Development Variance Permit PL2021-8939

Date: September 7, 2021
To: Donny van Dyk, Chief Administrative Officer
From: Nicole Capewell, Planner II
Address: 182 Van Horne Street & 175 Abbott Street
Subject: Development Variance Permit PL2021-8940

THAT Council deny "Development Variance Permit PL2021-8940" for Lot 10 District Lot 202 Similkameen Division Yale District Plan EPP91681, located at 175 Abbott Street, and Lot 4 District Lot 202 Similkameen Division Yale District Plan EPP91681, located at 182 Van Horne Street, a permit to vary Section 10.6.3.2 of Zoning Bylaw No. 2021-01, to allow vehicle access from the street for a duplex development.

Figure 2 - 175 Abbott Street Parking Layout

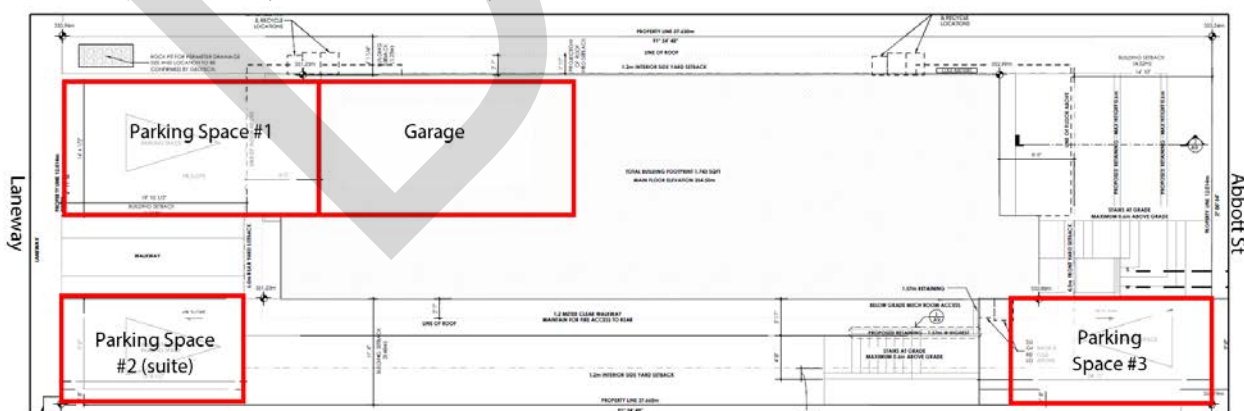
The current proposal for 175 Abbott Street includes a duplex development with one suite proposed, totaling 3 units. The total parking required for this development is 3 parking spaces. The width of the property is wide enough that 4 parking spaces could be accommodated off of the laneway. The current design however, proposes 2 surface parking spaces and 1 parking space located inside a garage from the laneway. Staff consider that the lot is wide enough to meet and exceed parking requirements by maintaining access only from the laneway.

Figure 3 - 182 Van Horne Street Parking Layout

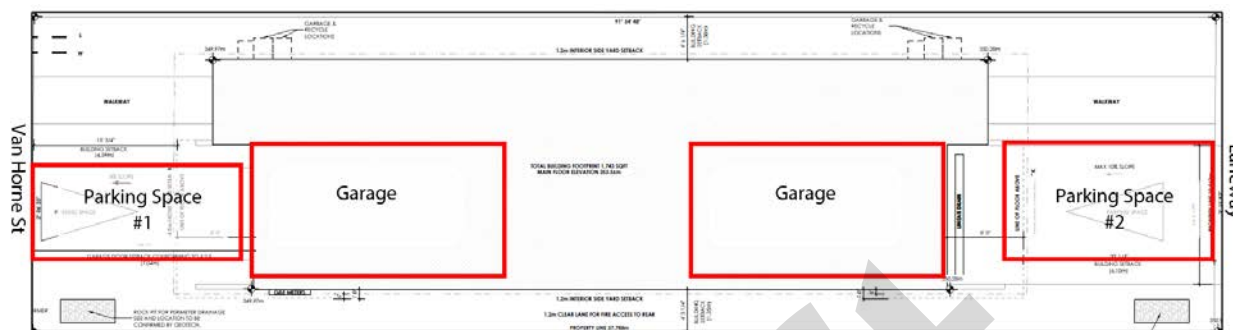
The current proposal for 182 Van Horne Street is for a duplex development, totaling 2 units. The development is designed as a front to back duplex with each unit having a garage on its respective side of the property. This results in one garage facing the street and one garage facing the laneway.

The width of the lot at 182 Van Horne Street is wide enough that 3 parking spaces could be accommodated off of the laneway, which would exceed the Zoning Bylaw requirement of 2 parking spaces. As such, staff consider that the lot is wide enough to meet and exceed parking requirements by maintaining access only from the laneway.
